### Appendix C

#### Consultations

### Ashton Dam, Cumberland, RI FERC No.P-14634

#### **AST/SD Project Footprint Comparison**

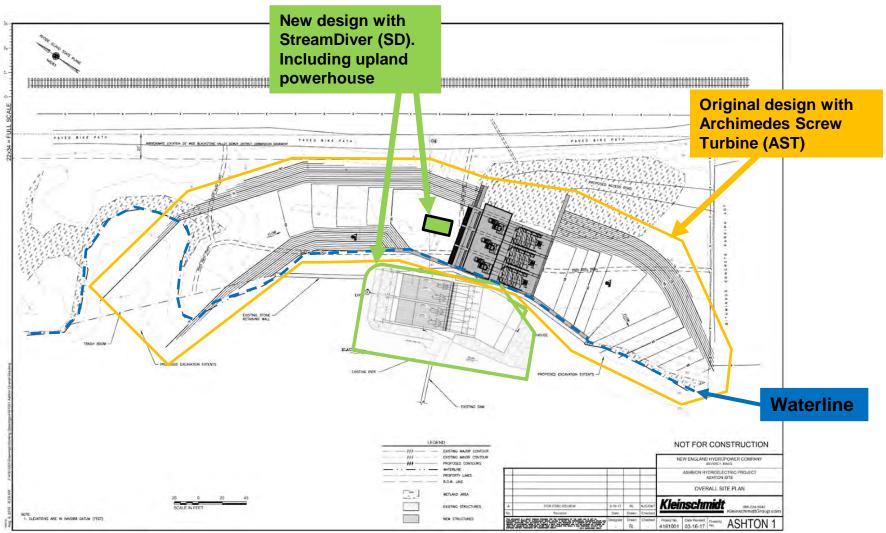
The current design is for the installation of four StreamDiver unregulated, fully submersible Kaplan-style turbines that will be located in the River beneath the surface of the water. The upland portion of the site will no longer be excavated for use. Instead, the existing lower-level spillway of the Ashton Dam will be reconstructed to house the new turbines. A drop gate to replace the gating structure washed out in the 2010 flood will be reconstructed along the lower-level spillway's crest to allow for the appropriate flow through the submerged turbines and return a veil flow of water to the main dam crest. This new design will have a direct effect on the Ashton Dam, but very little effect on the upland and riverbank near the Dam.

Previous Structure	Previous Design Dimensions	Currently Proposed Structure	Proposed Design Dimensions
Steel Archimedes Screw	Length: 20.4 ft	StreamDiver submerged	Length: 13.39 ft (3 large units) 10.61 ft (1 small unit) Diameter: 7.73 ft (3 large units) 5.98 ft (1 small unit)
Turbine (3)	Diameter: 13.5 ft	Kaplan turbines (4)

# Limit of Disturbance with AST's

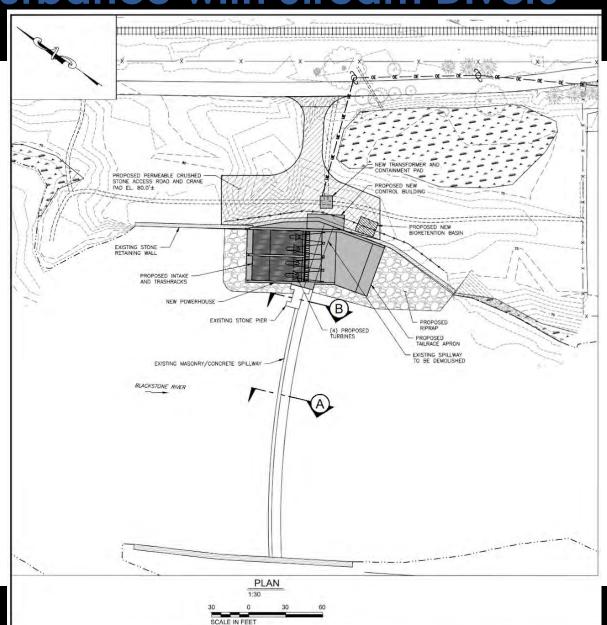
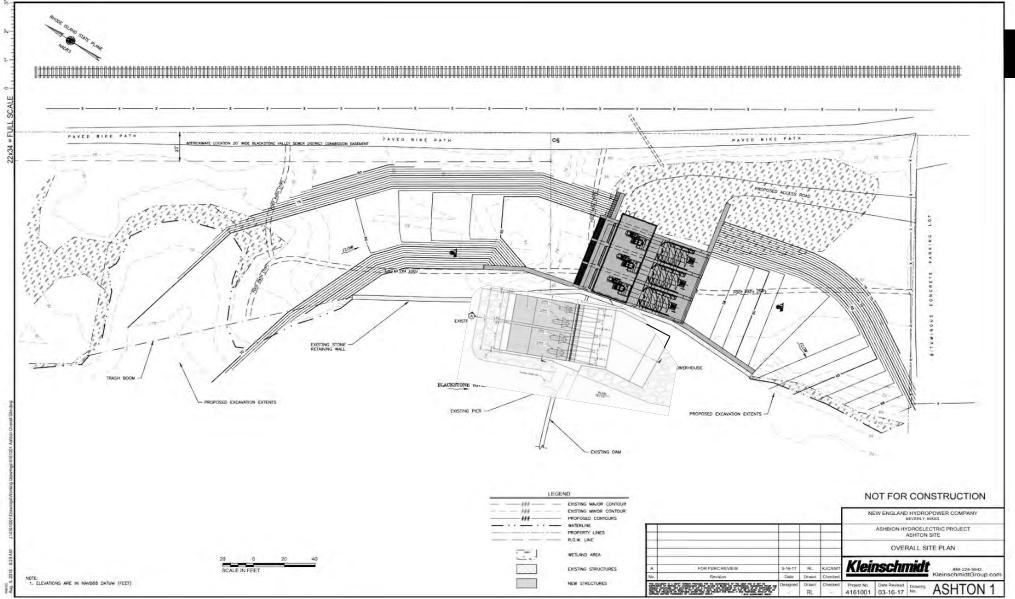
**NB:** A significant issue was raised by Chuck Horbert re: operations of the drop gate and the potential impacts on upstream water levels during normal and flood conditions. The goal is to mimic existing flow conditions. **NEHC will: (1) provide better understanding of** gate operations, integration of control systems, and automated controls and (2) will forward any relevant operational information from the Notre Dame 10-SD project to all participants.

Jenny Jones described the approach to assessing flooding. The assumption for modeling is the 100-year flood. Using FEMA effective model to revise the cross sections based on existing conditions, the intent being to look at the existing conditions as they are now. She is using a steady state (not a full dynamic model) single inflow model but can expand to dynamic model if the agencies so request. Based on the data, there should be no increase in pre- and post-construction flood levels.
